We thank the reviewers and the editor for their thorough and useful reviews.

Response to General Comments from Eva Mekis

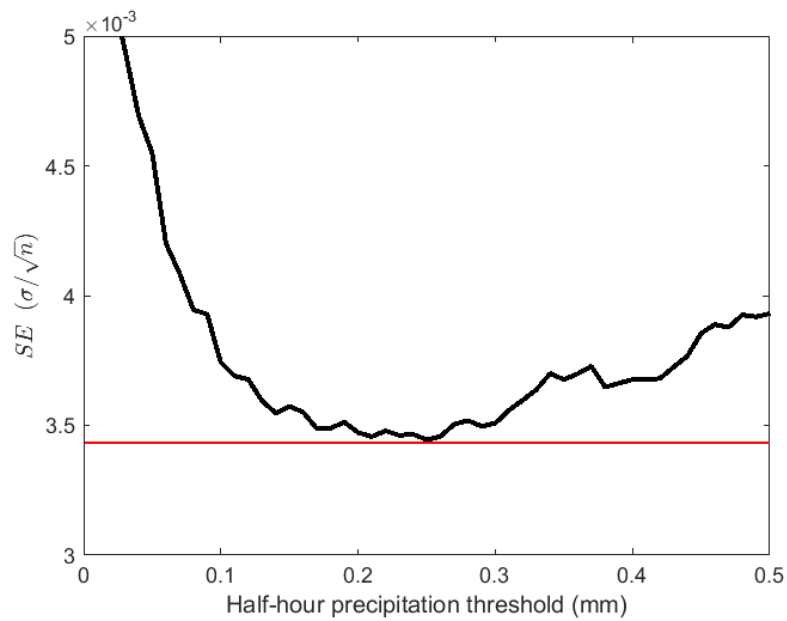
- The use of 0.25 mm lower limit for the standard (reference) gauge is debatable based on Figure 3, the SE minimum value is around 0.1 mm.

Mekis rightly commented that the use of a 0.25 mm minimum threshold is somewhat arbitrary. For example, another statistic could be used instead of the standard error to select this threshold. In addition, the threshold determined using the standard error is sensitive to both the size of the dataset being analyzed and the amount of noise in the measurements. The resultant threshold may therefore change with the length of the measurement campaign, the frequency of precipitation, the site, the gauge, and the shield. However for the sake of consistency, in the current manuscript the same threshold was selected for all the gauges evaluated. It is also true that the standard error for a threshold of 0.1 mm was quite similar to a threshold of 0.25 mm, and it is difficult to discern a significant change in the standard error in this region on Figure 3 of the manuscript under discussion. However as shown in the modified Figure 1R (included at the end of this document), where the scale of Panel c of Figure 3 has been altered to better resolve the minimum in the standard error, the standard error was indeed lower at 0.25 mm than at 0.1 mm.

Authors' response: See Figure 1R near the end of this document, and also the response above to the general comments from Mekis.

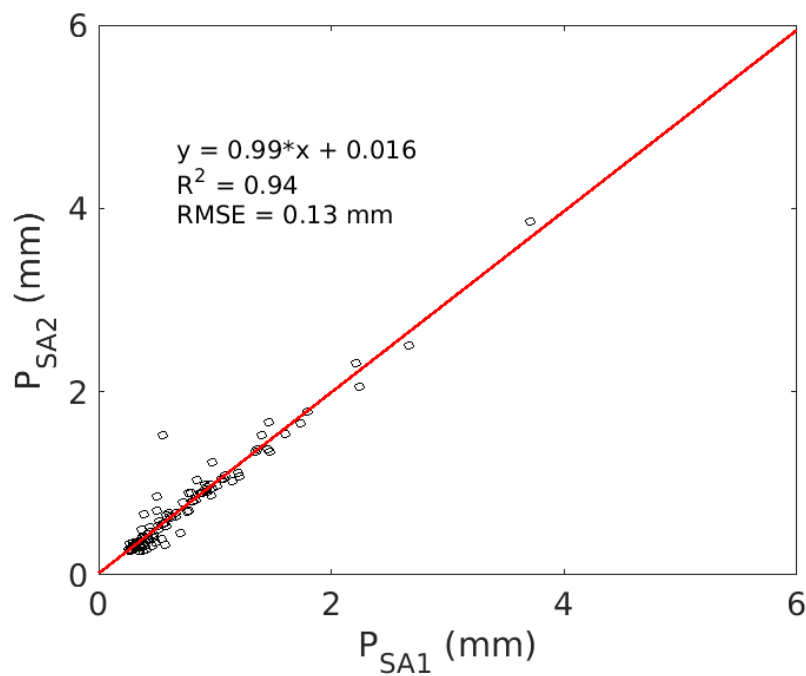
- 10 - Is there any NOR pair to be included?

Authors' response: We'll include a similar comparison plot for a pair of single Alter gauges from Norway. Figure 2R below shows the available measurements. There were some issues that affected the comparison of the two single Alter gauges, but we can describe these in more detail in the revised manuscript.
